Site Accessibility Evaluation

Americans with Disabilities Act Title II (Public Services: State and Local Government)

EPC Veteran Services

**5850 Championship View
Colorado Springs, CO
80922**

Finding: 1

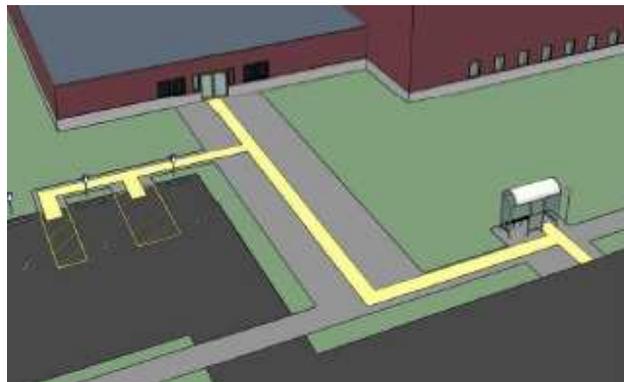
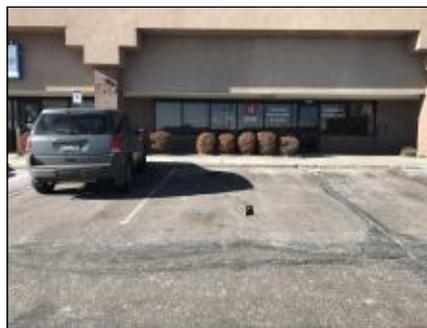
The accessible parking is not located on an accessible route of travel to the accessible building entrance.

No accessible pedestrian ramp or access aisle exists

Move the existing accessible parking stall and access aisle 3 to 4 stalls over (north). The cross slope of that section of the parking lot is compliant or very close to meeting the 2% maximum. The running slope will have to be addressed as it currently exceeds the 2% maximum and is somewhere between 4 to 5%.

- It will require new asphalt/concrete and grading but it is easily achievable due to the minimal grade/slope of that section of the parking lot.
- Additionally, a parallel pedestrian ramp will be required to grant access to the sidewalk for wheelchair users thus allowing entrance to the veterans office. Parallel pedestrian ramp will have to be constructed and connect to the existing sidewalk

Finding: 2

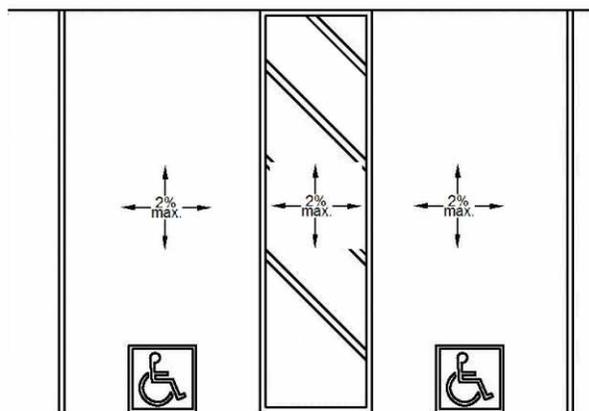
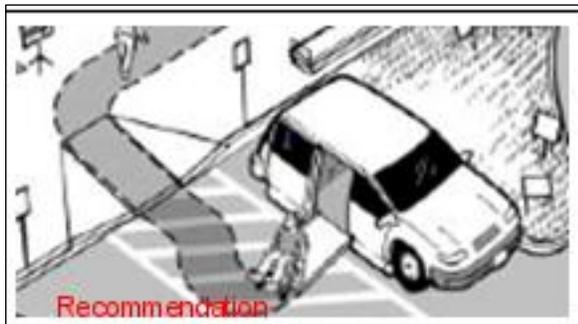
The accessible parking stall's access aisle contains a built up curb ramp which results in significant slopes greater than 2 percent.

Asphalt ramp protruding into parking access aisle with a running slope of 12.3%

Remove protruding ramp and design/construct parallel curb ramp into existing sidewalk not to exceed 8.33% running slope and 2% cross slope. Note: that this property is a lease, and the landlord is responsible for the correction.

Finding: 3

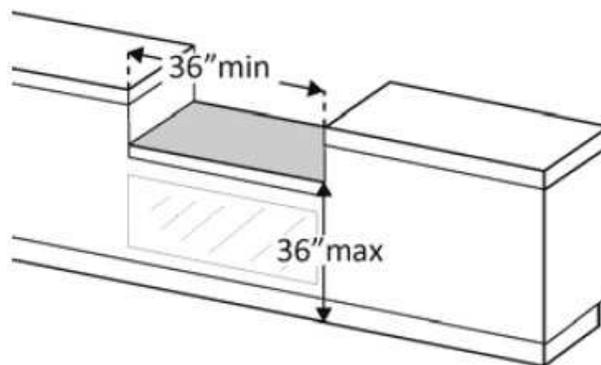
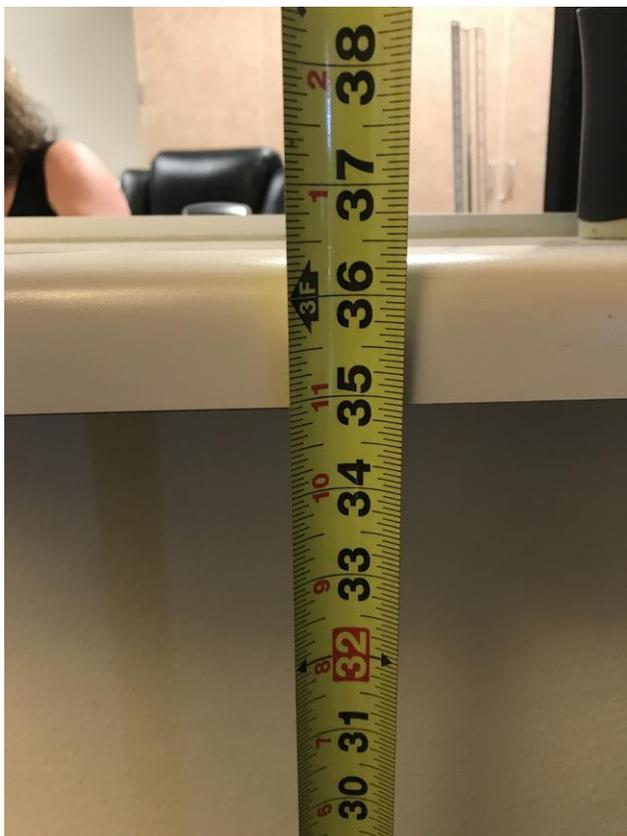
The transaction counter is too high.

36.25 inches above finished floor

Replace or re-configure a section of the transaction counter to provide a clearance of 36 inches high and a minimum of 36 inches wide.

Finding: 4

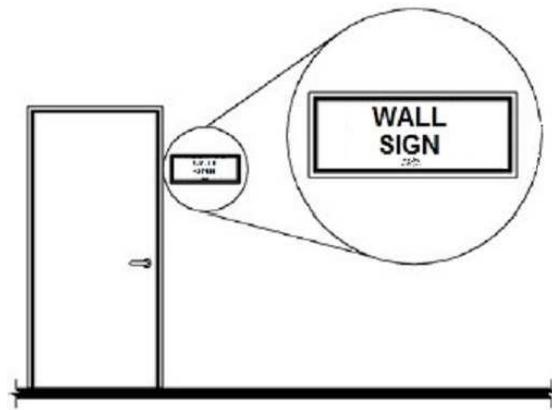
The tactile sign is incorrectly located.

Located on door.
Submit w/o to relocate sign.

Submit a work order to have sign reinstalled.

Corrective Action: W/O 386286 submitted. Relocated sign on 4/03/2017.

Finding: 6

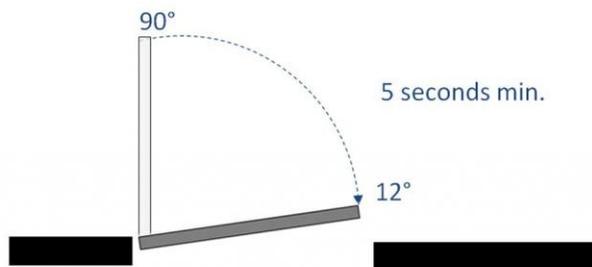
The door is equipped with a door closer and returns to a closed position too quickly.

Closer takes 3.8 seconds to close.

Submit work order to have door closer adjusted.

Corrective Action: W/O 381234 completed 2/1/2017.

Finding: 7

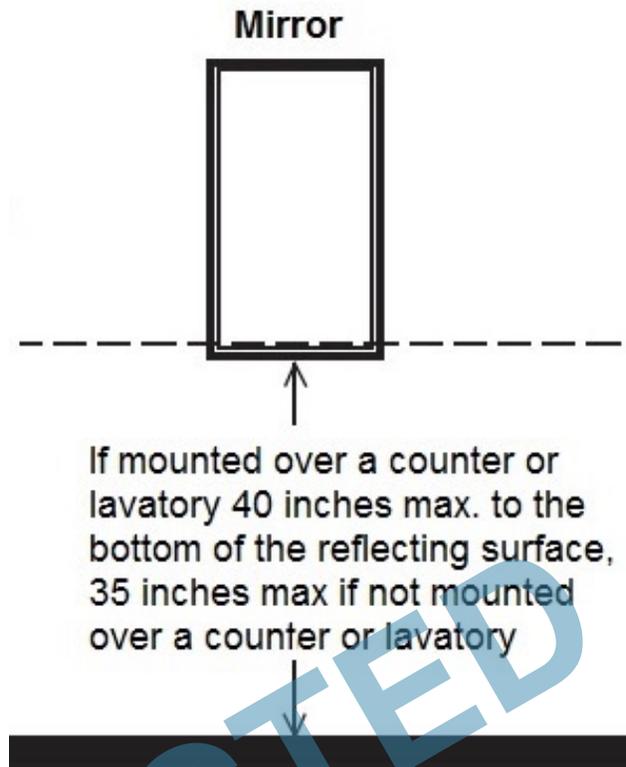
The mirror is mounted too high.

Mounted at 43 inches
above finished floor

Submit work order to have mirror lowered to 40 inches.

Corrective Action: W/O 381233 submitted. Completed 4/6/17. Mirror added to right side of lavatory with bottom edge of the reflecting surface at 35 inches above finished floor. Verified on 8/7/19

Finding: 8

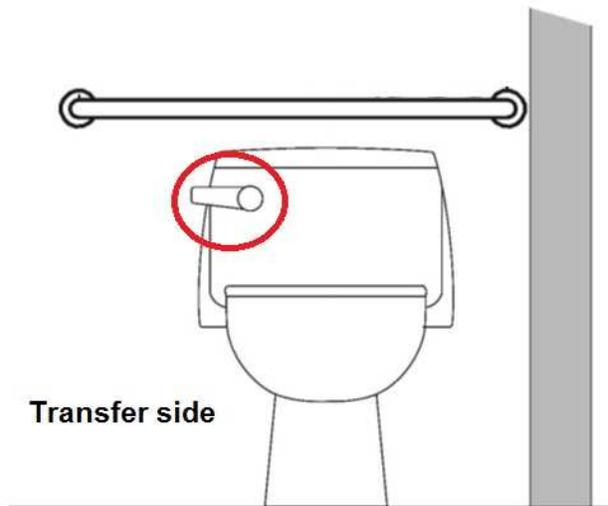
The flush handle is located on the wrong side of the toilet.

Flush control located on closed side.

Submit a work order to move flush control to open side.

Corrective Action: W/O 381232 submitted. Installed new tank w/ handle on left side-completed 3/7/2017.

Finding: 9

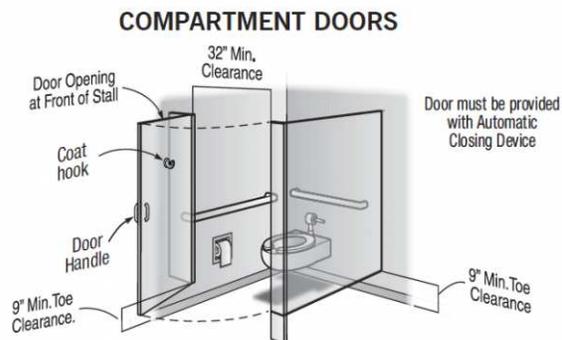
The compartment door is not self closing.

Stall door does not self-close.

Submit a work order to replace or adjust existing door closer.

Corrective Action: W/O 381231 submitted.

Finding: 10

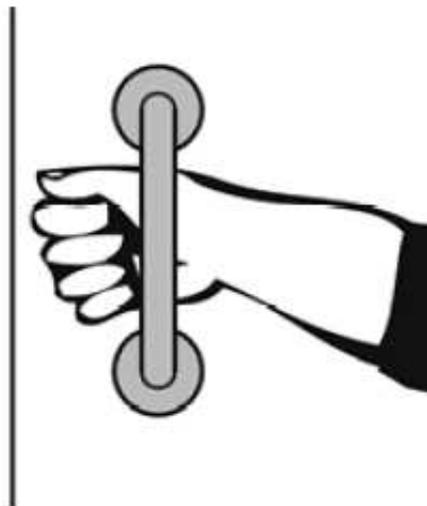
The water closet compartment door is missing a loop handle.

No loop handles installed.

Submit a work order to have loop handles installed on stall door.

Corrective Action: W/O 381230 submitted. Corrected 2/1/2017.

Finding: 11

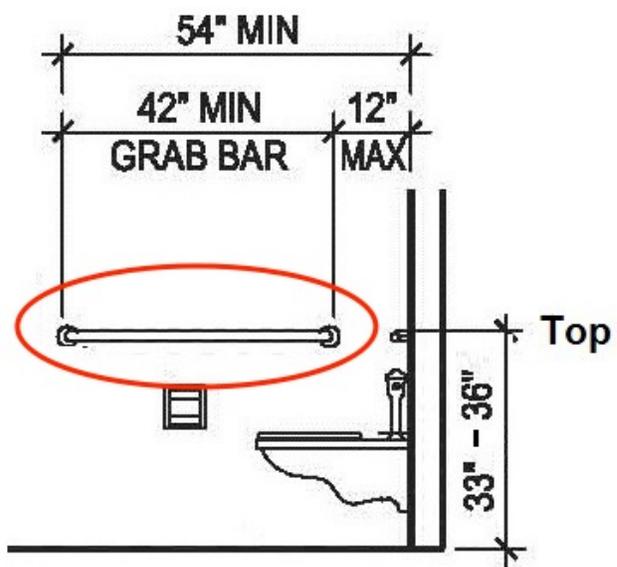
The side grab bar is too high.

36.75 inches above
finished floor

Lower side grab bar 1 inch to meet compliance.

Finding: 12

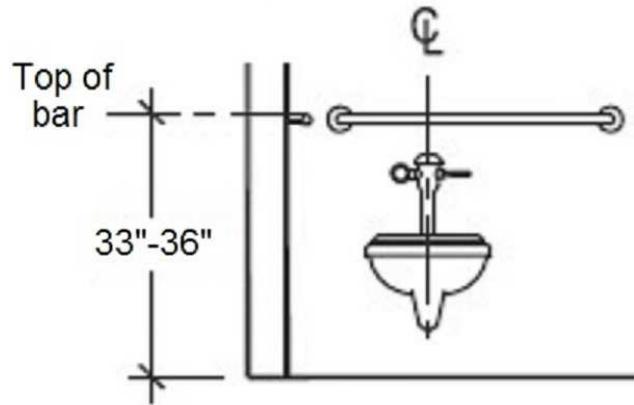
The rear grab bar is too high.

37 inches above
finished floor

Lower rear grab bar 1 inch minimum to meet compliance.

Finding: 13

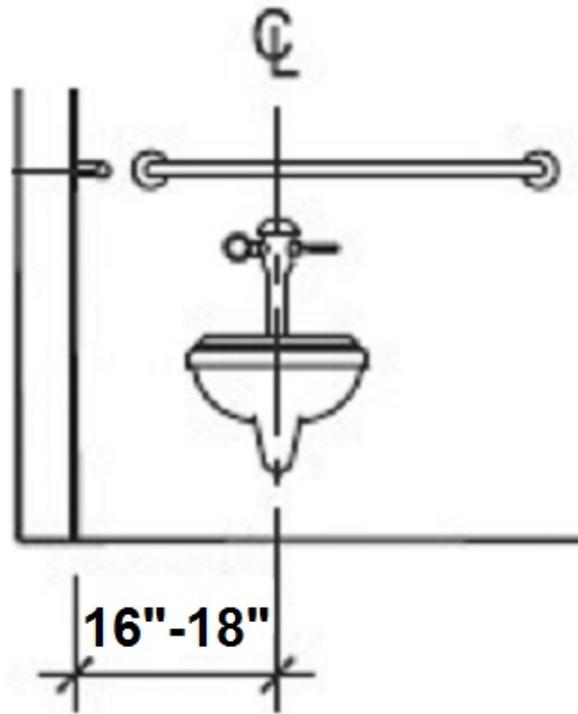
The toilet is not located within the range allowed from the side wall or partition.

19.25 inches from side wall

Adjust toilet so that it measures between 16 and 18 inches measured from the side wall to the centerline of the toilet.

Finding: 14

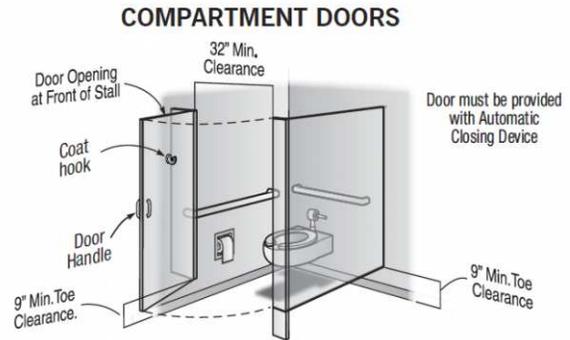
The compartment door is not self closing.

Stall door not self closing

Install or adjust compartment door hinges to make compartment door self close.

Finding: 15

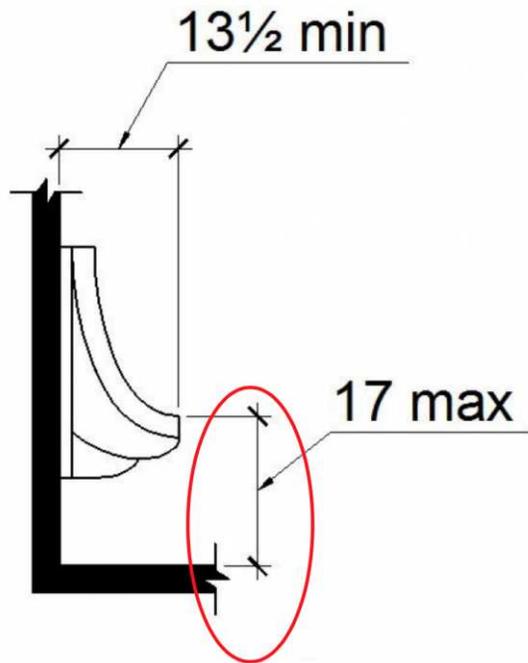
The rim of the urinal is too high.

23 inches above
finished floor

Lower urinal a minimum of 6 inches to ensure a 17 inch maximum height above finished floor.

Finding: 16

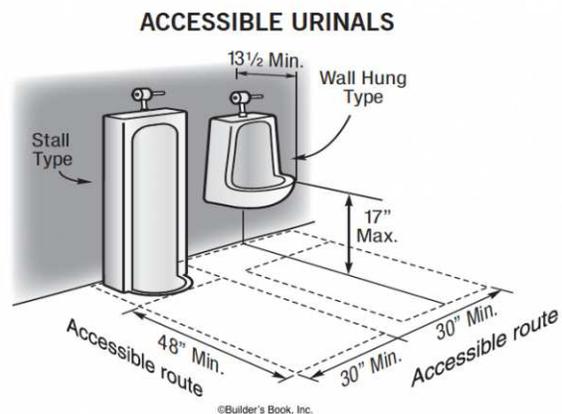
The urinal is too close to the side wall.

12.25 inches from
nearest side wall

Re-position right side wall partition to provide a an additional 2 inches in width if the the left side wall partition is unable to provide 3 inches due to the required clear floor space of 60 inches needed at the water closet. The additional 2 inches will provide the required 30 inch width minimum required. Note that urinal will not be centered to the required clear floor space.

Finding: 17

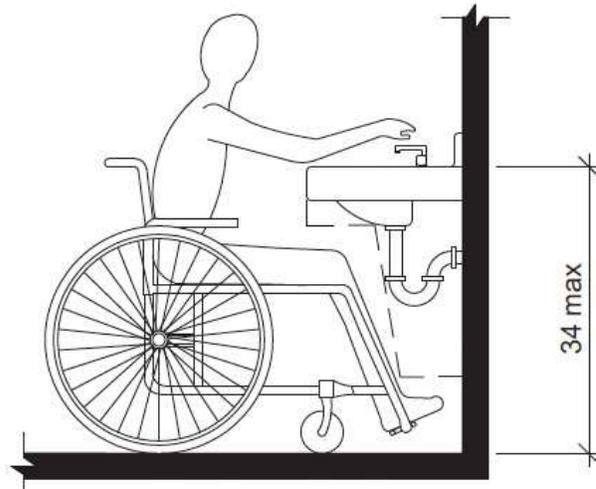
The top rim of the lavatory is too high.

34.25 inches above
finished floor

Lower lavatory by a minimum of .5 inches to ensure top rim of lavatory does not exceed 34 inches above finished floor.

Finding: 18

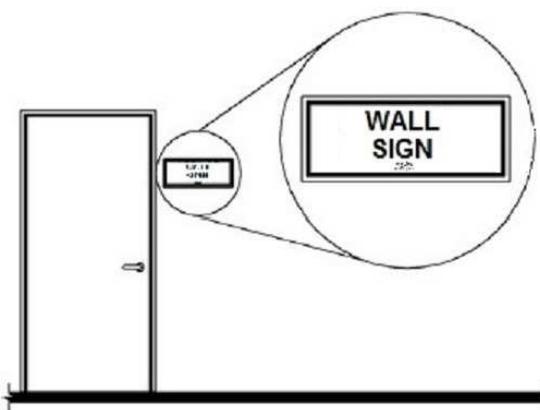
The tactile sign is incorrectly located.

Located on door.

Submit work order to relocate sign.

Corrective Action: W/O 386080 submitted on 1/26/2017.

Finding: 20

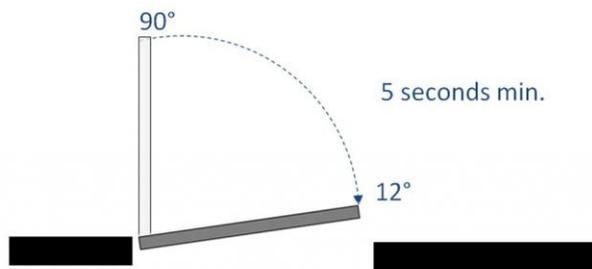
The door is equipped with a door closer and returns to a closed position too quickly.

Closer takes 2.7 seconds to close.

Submit a work order to adjust closer.

Corrective Action: W/O 381228 completed 02/01/2017.

Finding: 21

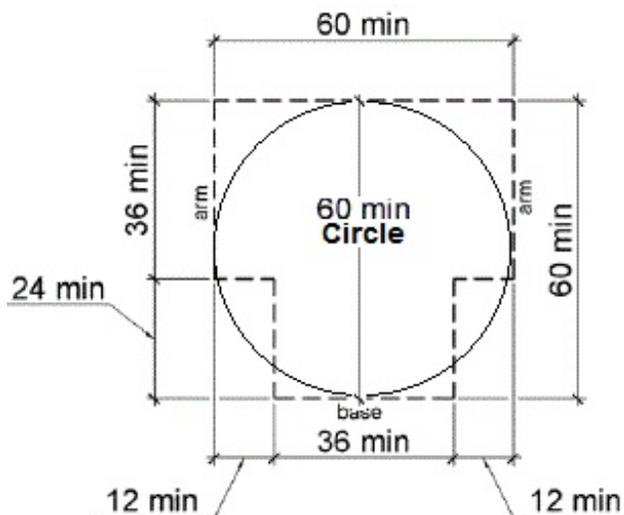
The restroom contains storage items and/or supplies which obstruct the clear floor and/or turning space within the restroom.

Measures 38 inches.

Submit a work order to have plan for budget and corrective action.

Corrective Action: W/O 381227 submitted. Corrected 2/1/2017.

Finding: 22

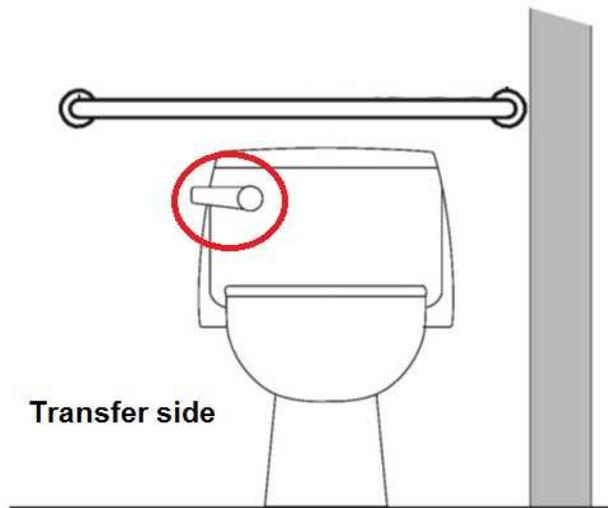
The flush handle is located on the wrong side of the toilet.

Flush control on closed side.

Submit a work order to move flush control to open side.

Corrective Action: W/O 381225 submitted. Installed new tank w/ handle on left side-completed 3/14/2017.

Finding: 23

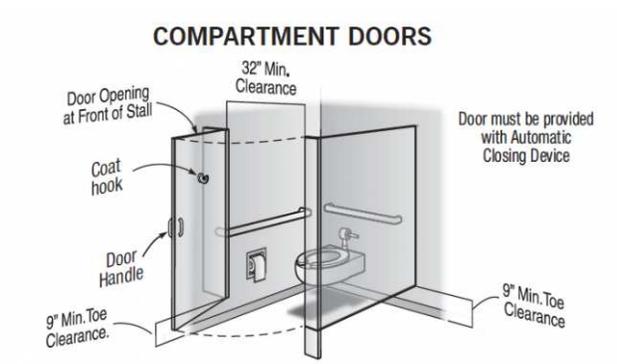
The compartment door is not self closing.

Door does not self-close.

Submit a work order to add or replace closer.

Corrective Action: W/O 381224 submitted.
